NOTICE OF A TYPE I DECISION ON A PROPOSAL IN YOUR NEIGHBORHOOD

CASE FILE NUMBER: LU 18-226807 HR: PROPOSED DETACHED GARAGE

The applicant seeks Historic Resource Review approval for the addition of a detached garage at the rear of the site. The proposed garage will be 24 feet in length and 16 feet in width and located 4 feet from the rear lot line abutting the alley and 3 feet from the northeast side lot line. It will be 14'-2" in height, from finished grade to the peak of the gabled roof. Cement-

FRONT ELEVATION - SOUTHEAST
 SCALE: 1/4" = 1'-0"

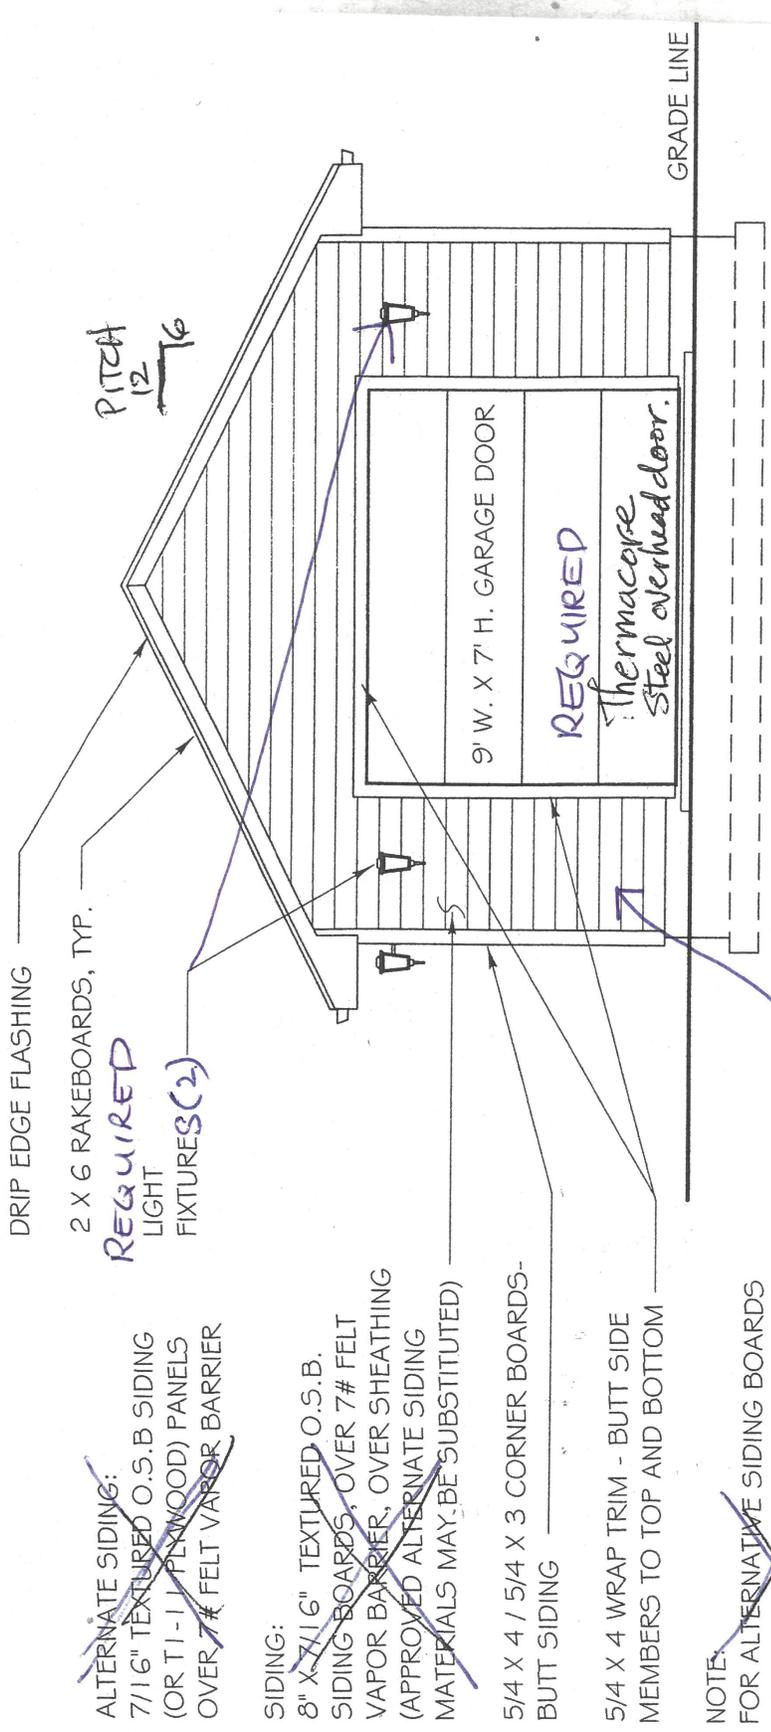
ALTERNATE SIDING:
~~7/16" TEXTURED O.S.B SIDING
 (OR T1-11 PLYWOOD) PANELS
 OVER 7# FELT VAPOR BARRIER~~

SIDING:
~~8" X 2 1/2" TEXTURED O.S.B.
 SIDING BOARDS, OVER 7# FELT
 VAPOR BARRIER, OVER SHEATHING
 (APPROVED ALTERNATE SIDING
 MATERIALS MAY BE SUBSTITUTED)~~

NOTE:
~~FOR ALTERNATIVE SIDING BOARDS
 USE 1X TRIM BOARDS AND NAIL OVER
 SIDING PANELS~~

REQUIRED: SIDING
 Must be Hardie Plank Lap Siding
 Artisen series horizontal-6" Roveal-
 ALL ELEVATIONS. 5/8" thick
